GOVERNMENT OF THE DISTRICT OF COLUMBIA
DEPARTMENT OF TRANSPORTATION

MEMORANDUM

SUBJECT: ZC Case No. 18-01 – 1925 Vermont Avenue NW (African American Civil War Museum)

Figure 1 – Site Plan (Source: Exhibit 1E in 18-01 Case Record)

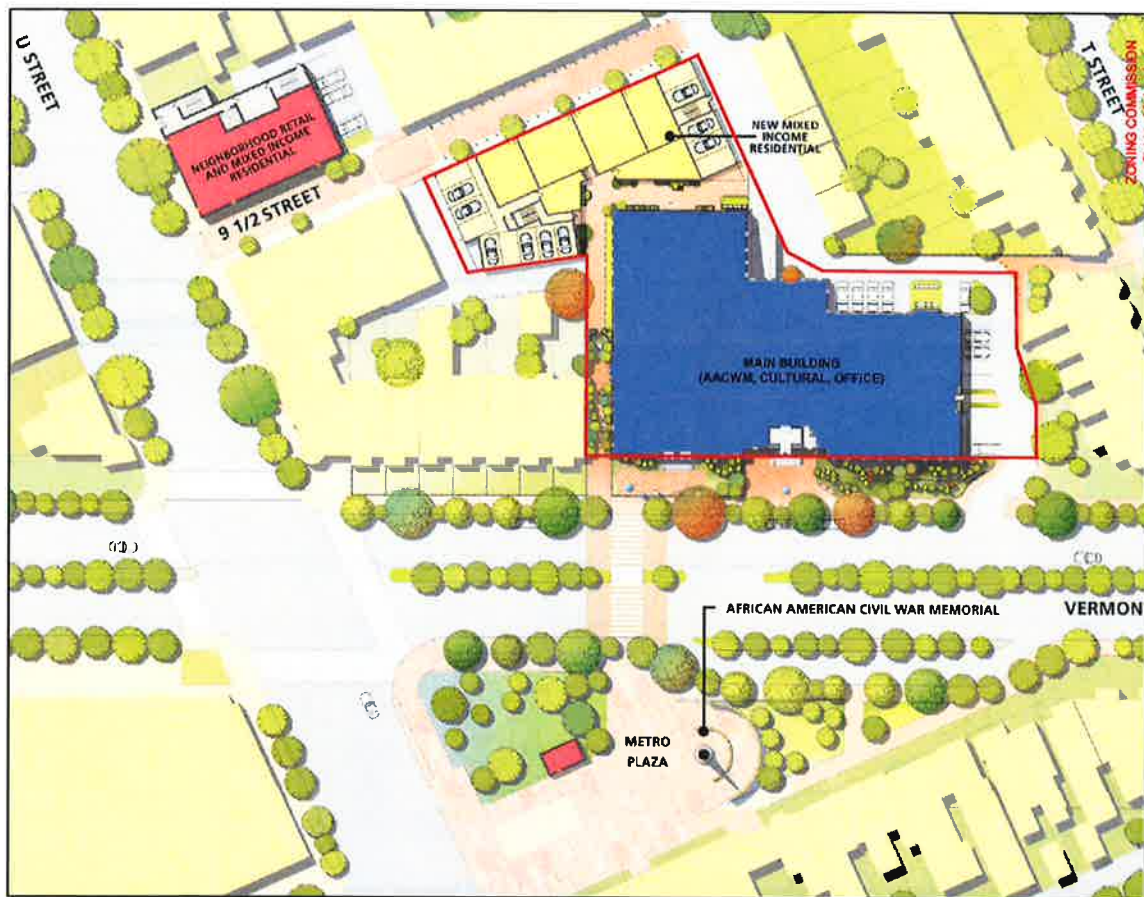
DDOT notes that the Applicant’s plans suggest a raised, midblock crosswalk across Vermont Avenue NW to connect the site to the African American Civil War Memorial and Metrorail Plaza, as shown in Figure 1. The proposed crossing will be reviewed during the public space permitting process. There are concerns with its proximity to the intersection of U Street NW and Vermont Street NW. Additionally, the crossing is located near an existing median break providing access to a WMATA bus layover loop. DDOT will request the Applicant to coordinate with WMATA on the necessity of the median break and may require its closure.
